Project No. 2021\_154

MIDLOTHIAN ISD STADIUM ADDITIONS AND RENOVATIONS

ADDENDUM NO. 2

DATE: October 18, 2021

2 PRESS BOX PORCH LEVEL  
1/8" = 1'-0" REF 5 / A-103

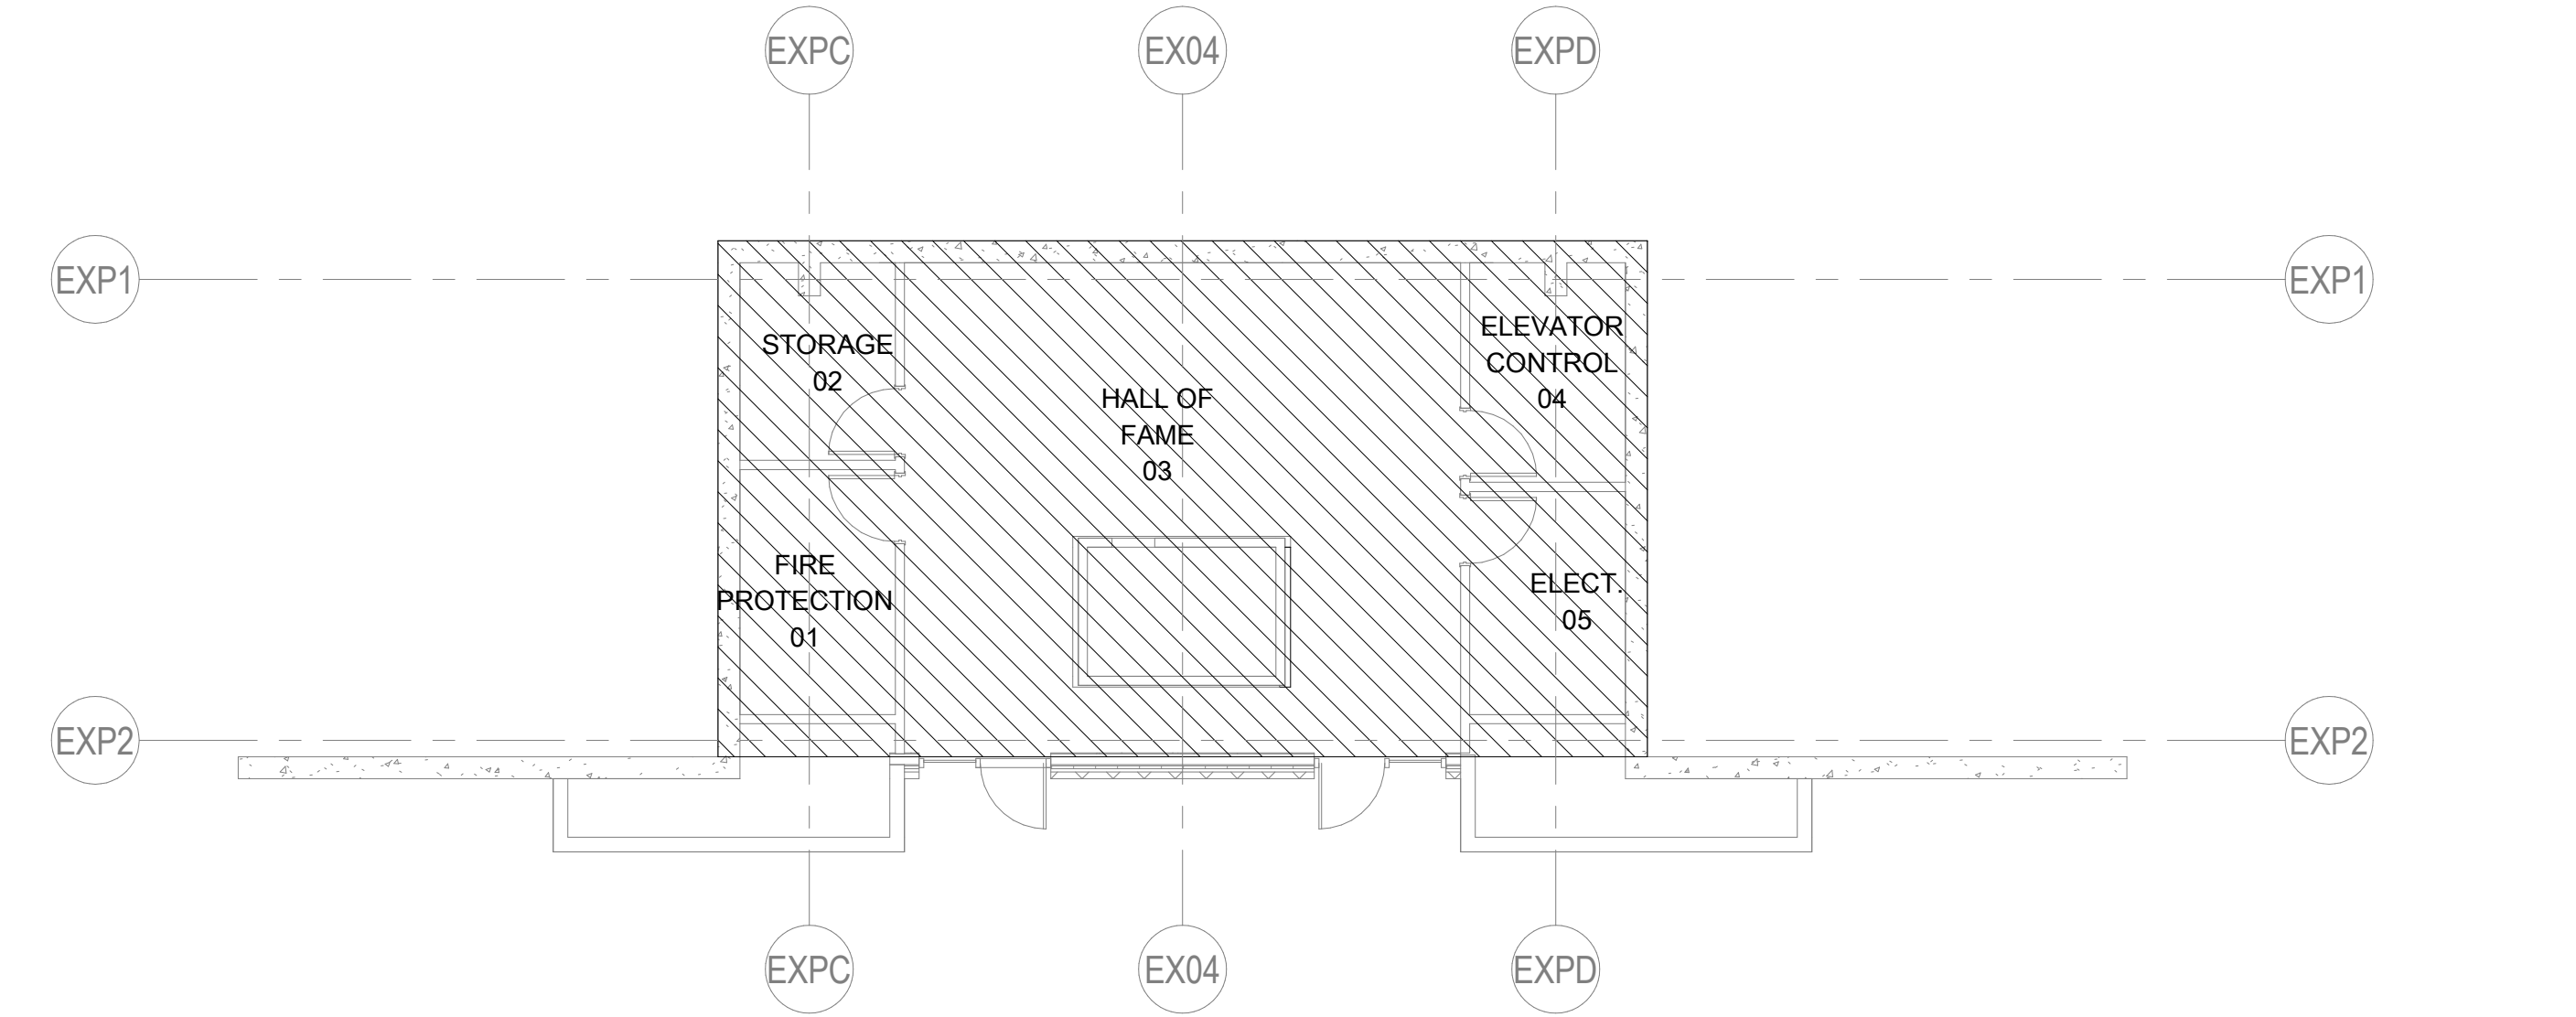
- A2.10 SHEET A-103 – PRESSBOX FLOOR PLAN:  
REMOVE and REPLACE in its entirety.  
a. Control Room 120 MOVED entirely to the other side of existing elevator. Door 121 will be installed in existing fire rated stair well.

b. DEMOLISH existing CMU wall area 3'-0" X 7'-4" to install new door.
- A2.11 SHEET A-113 – PRESSBOX RCP:  
REMOVE and REPLACE in its entirety.  
a. Control Room 120 ceiling MOVED entirely to the other side of existing elevator.

SHEET CONTENTS  
BUILDING ELEVATIONS

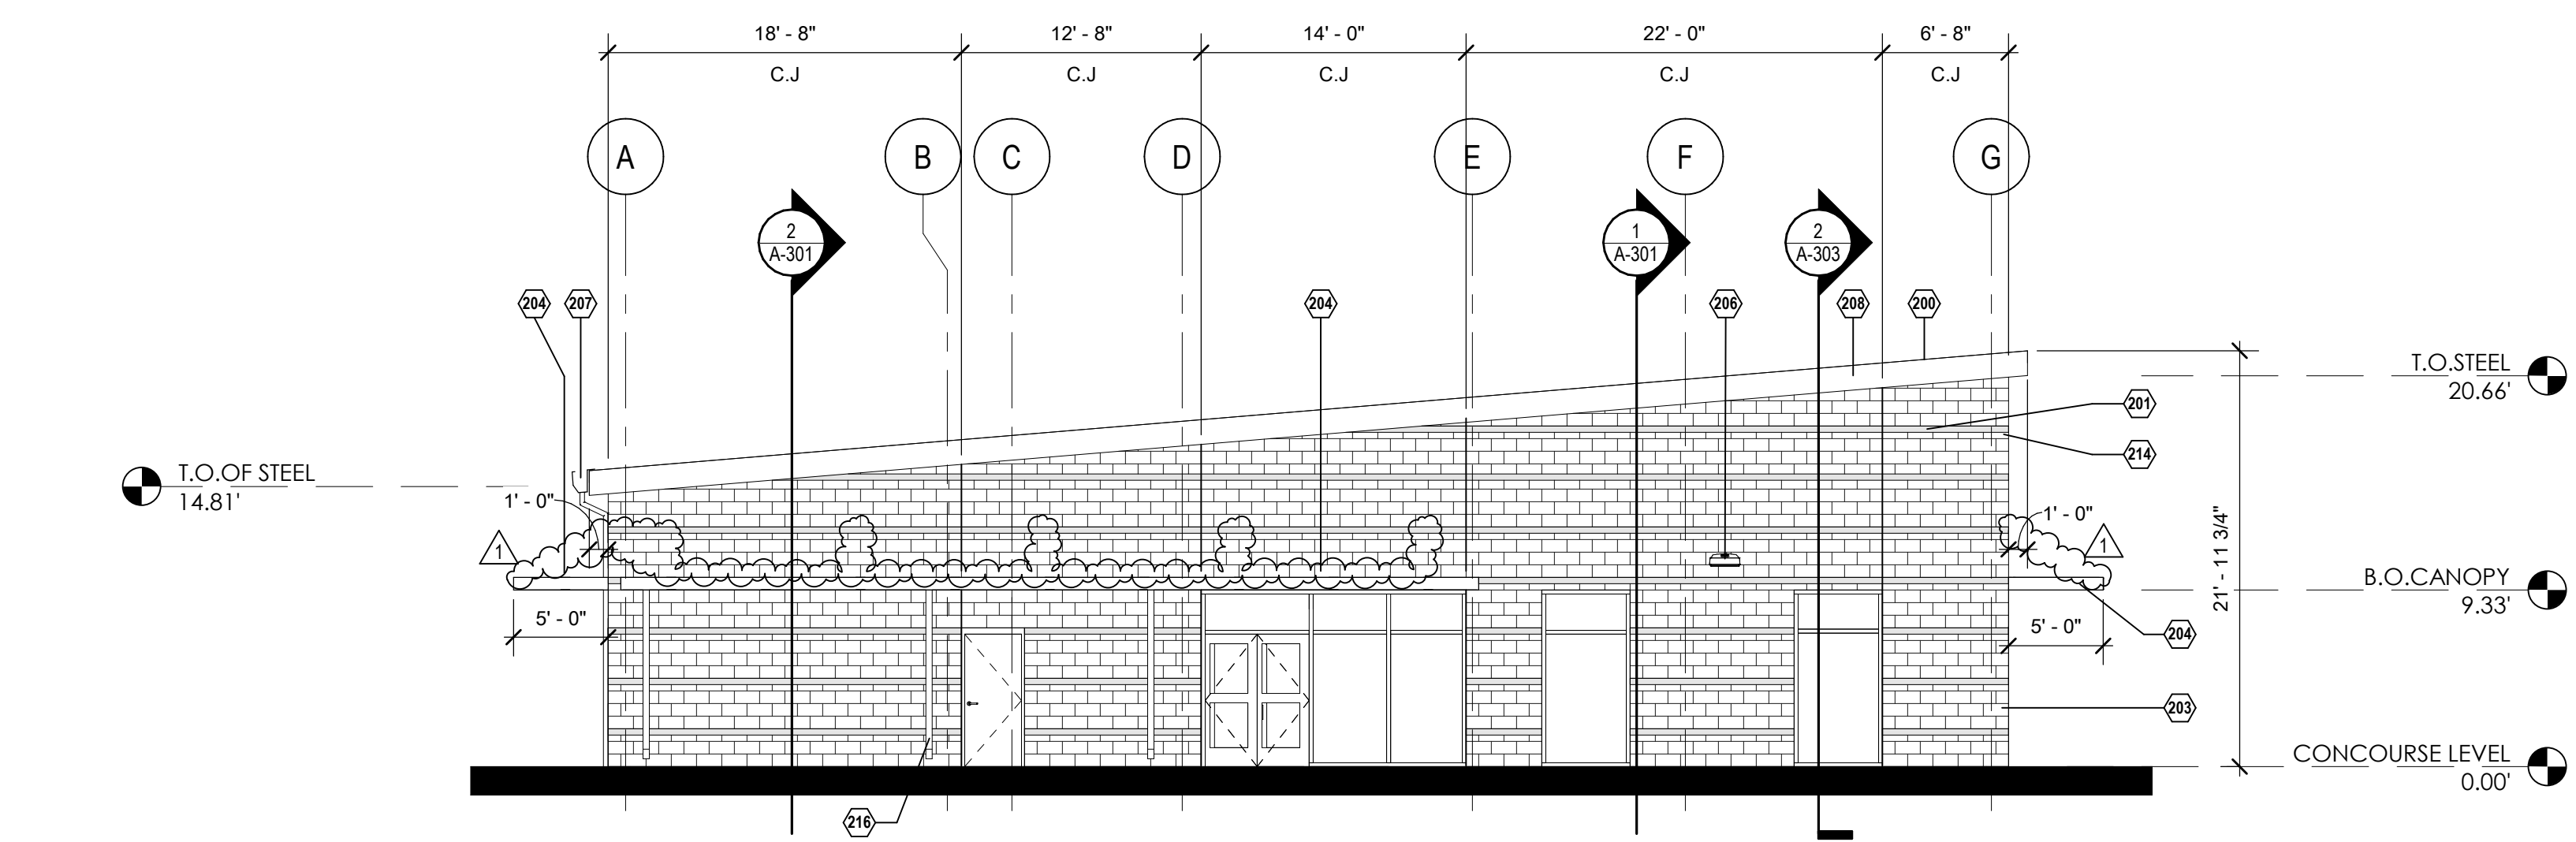
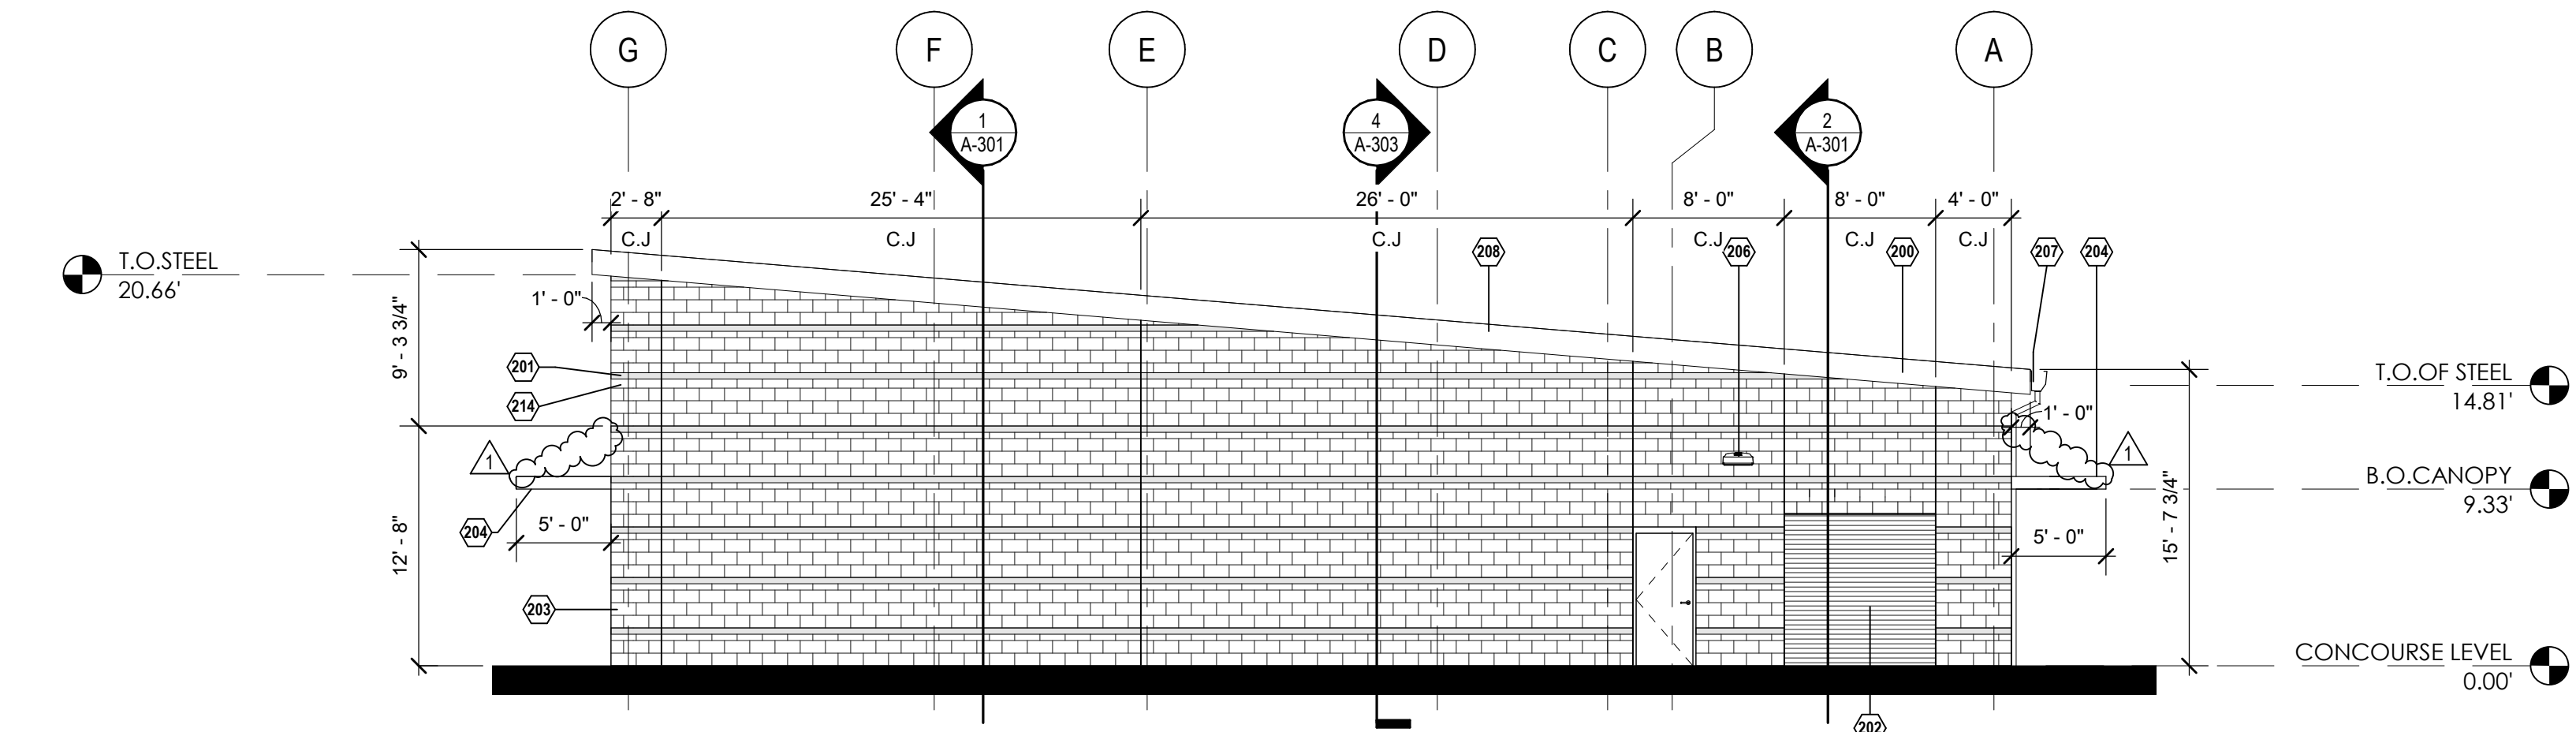
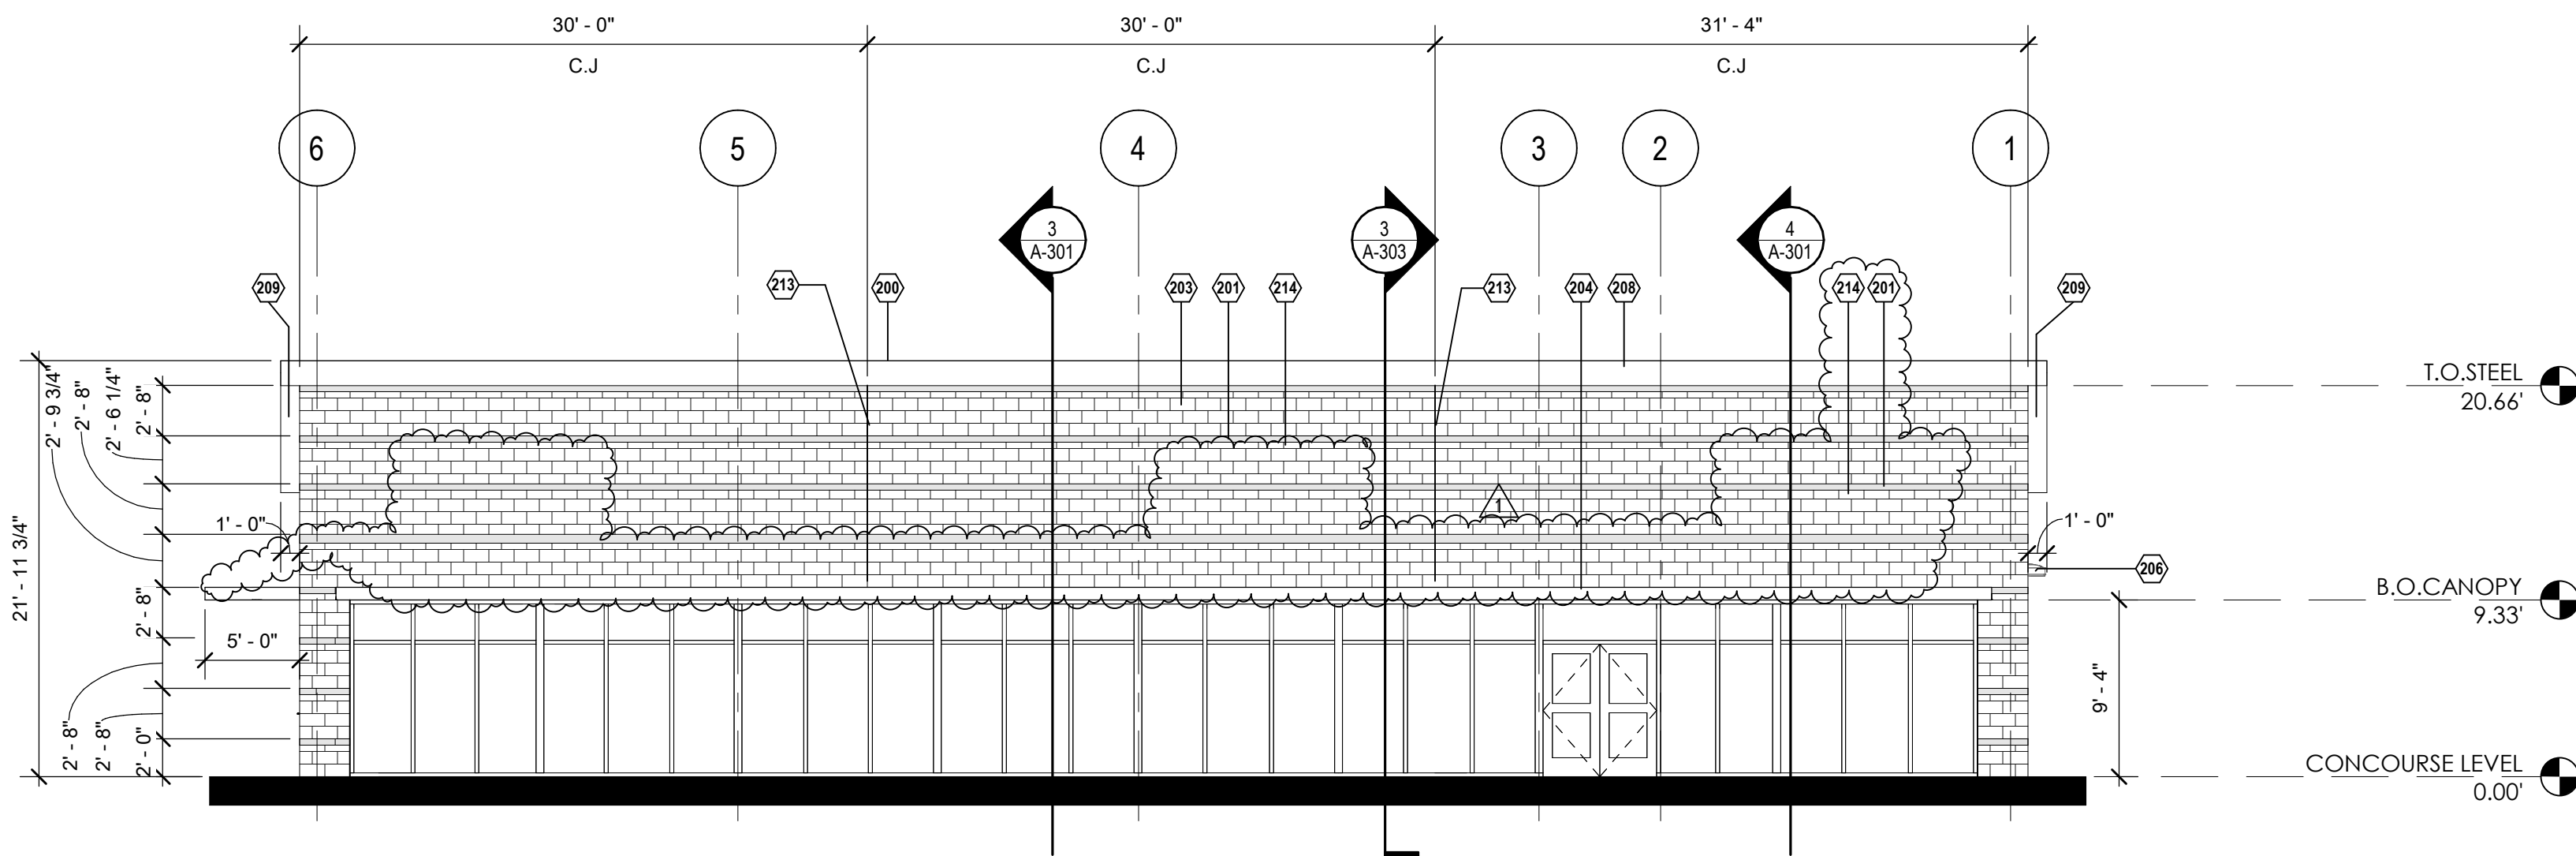
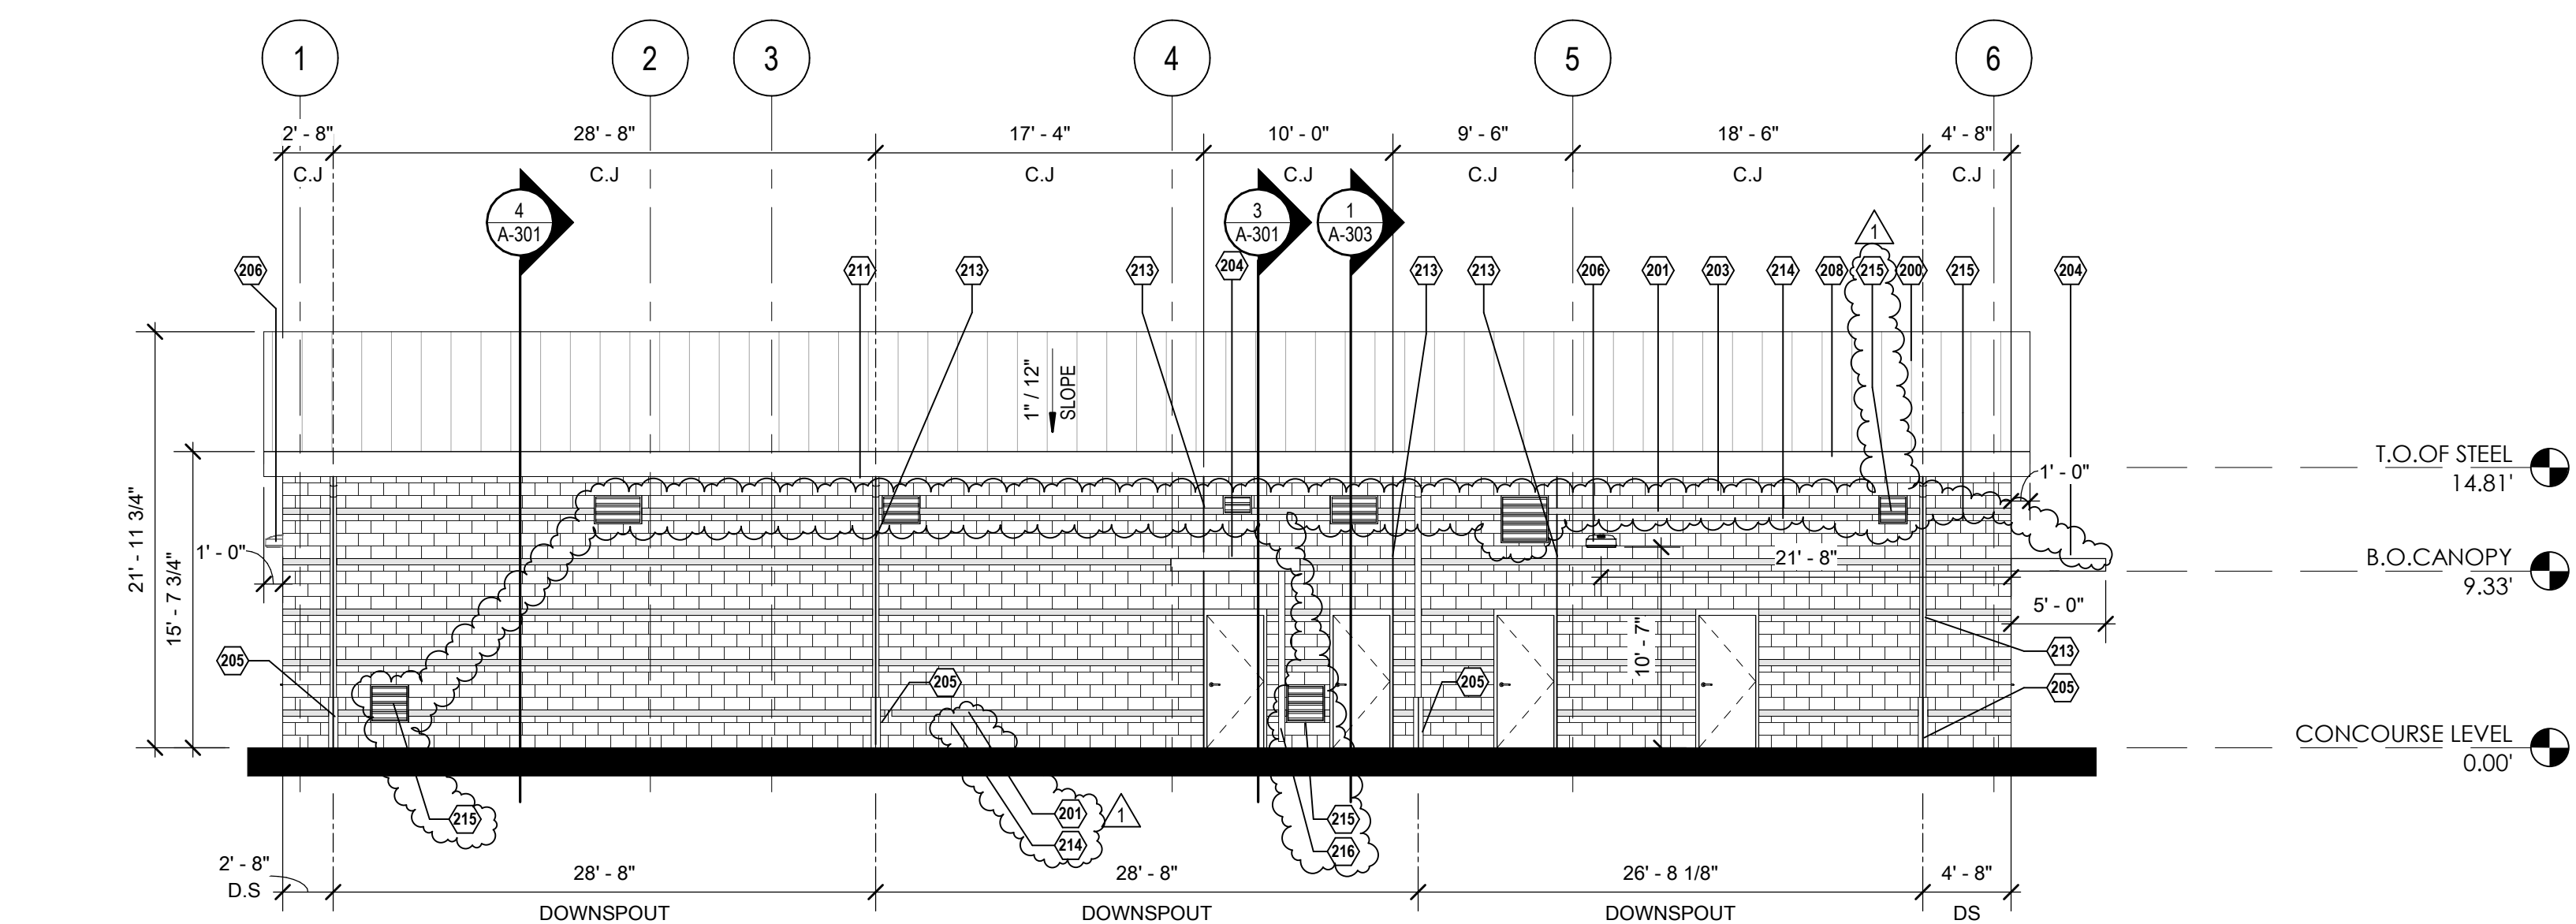
- A2.12 SHEET A-202 – BUILDING ELEVATIONS:  
REMOVE and REPLACE in its entirety.  
a. REMOVE steel tie backs  
b. ADDED storm louvers on exterior wall for air intake and exhaust air regarding mechanical equipment.
